# Certificate of Appropriateness

**Property** 1933 N. 1ST ST. Brewers Hill HD  
**Description of work** Install picket-style metal handrail in block on berm steps at front of house.  
**Date issued** 10/15/2018 PTS ID 114645 COA: handrail on sidewalk steps

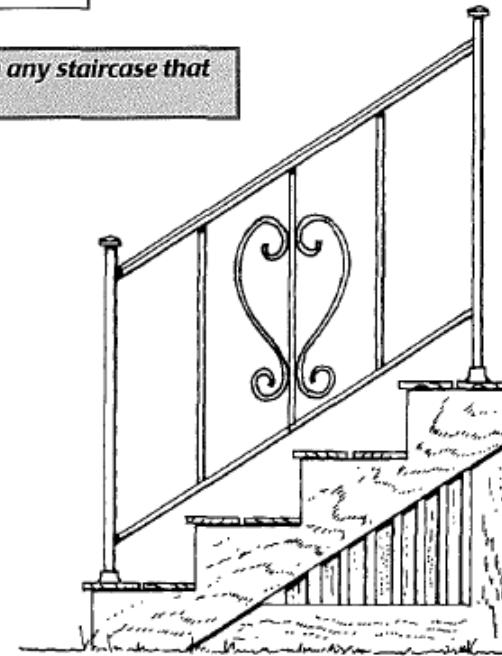
Ideal railing design. Pickets should be straight and plumb. Curlicues, such as at right, are not permitted.

This design is acceptable WITHOUT CURLICURES for sidewalk/berm steps. This kind of railing may not be used on porch steps.

Berm/sidewalk steps will have a metal handrail on one side.
